Service Technical Information

MODEL NO. AM-HX50 / HX55
SUBJECT With specific disc, unable to read TOC "DISC ERROR" appears

REF.No. :G - 99 - 051 - E0

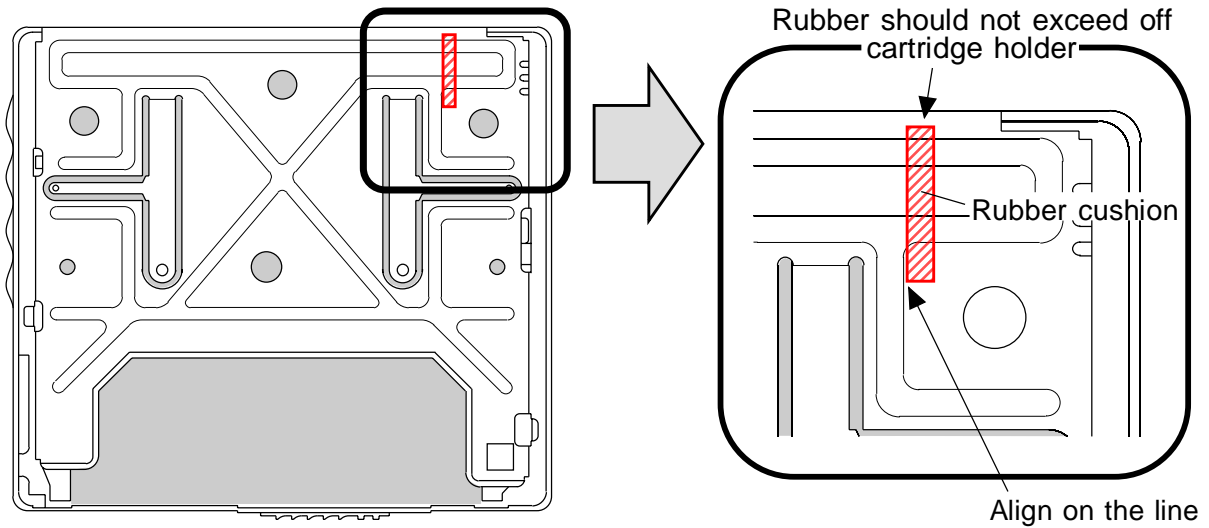
Unstable TOC reading may occur due to unstable disc holding.
Take the following countermeasure.

Remove the top panel, and attach a rubber cushion onto the cartridge holder (see figure below).

Ref.	Parts Code	Description	Remarks
-	8A-HM3-231-010	CUSH-R,CTRG	-
